REGIONAL REVIEW NOTIFICATION

Name of Proposal: **Anvil Block Road Project**
Review Type: Development of Regional Impact

Preliminary Report:	December 18, 2007	**DEVELOPMENT OF REGIONAL IMPACT REVIEW REPORT**	Project:	Anvil Block Rd Project #1618
Final Report Due:	January 17, 2008		Comments Due By:	January 1, 2008

SHEET TITLE:
DRI SITE PLAN

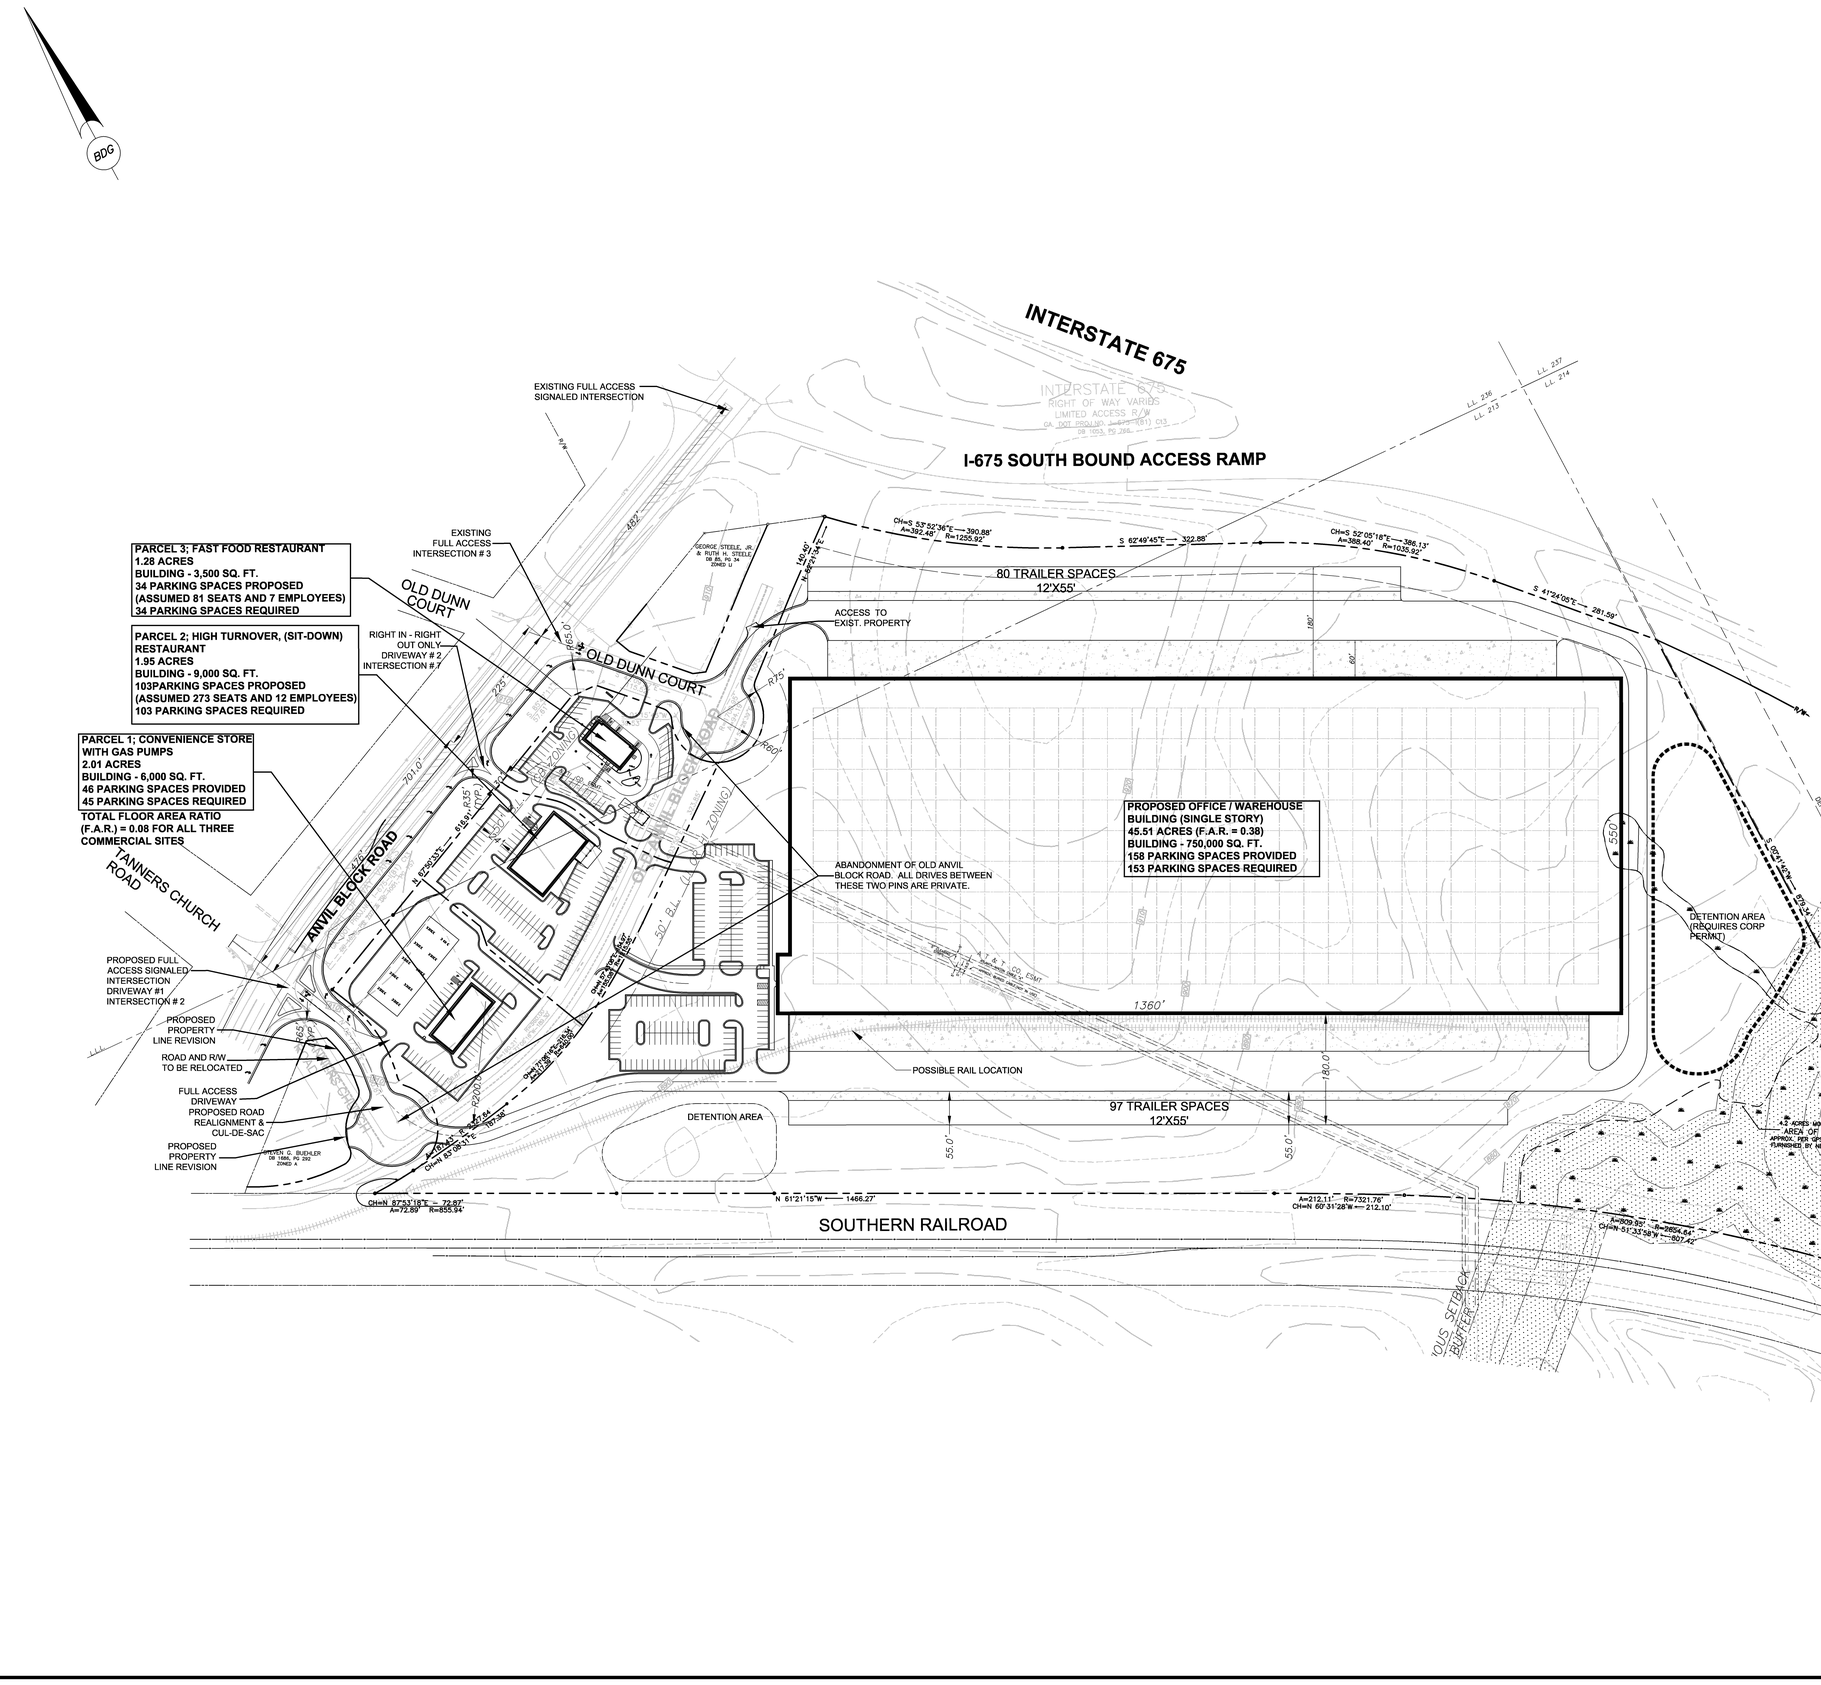
The proposed development is located in an area that is primarily dominated by other industrial and warehouse uses as well as undeveloped land within the County. It is important to consider compatible uses as the area continues to develop. The Regional Development Policies adopted by the ARC strive to advance sustainable development, protect environmentally sensitive areas, and create a regional network of greenspace. Mass grading and extensive removal of vegetation on the site should be avoided.

The project plans show two streams at the eastern end of the project property. Both show 50-foot buffers and additional 25-foot impervious surface setbacks consistent with the Clayton County Stream Buffer Ordinance. Any other waters of the state on the property will be subject to the State 25-foot Erosion and Sedimentation Act buffers.

- The site plan shows no sidewalks proposed along the adjacent public right of way or internal roads. *ARC strongly recommends the developer provide sidewalks that comply with ADA standards along Anvil Block Road and all internal driveways. Special attention should be paid to pedestrian safety at the proposed full-access driveway #1 where most of the vehicular access to the site will occur.*
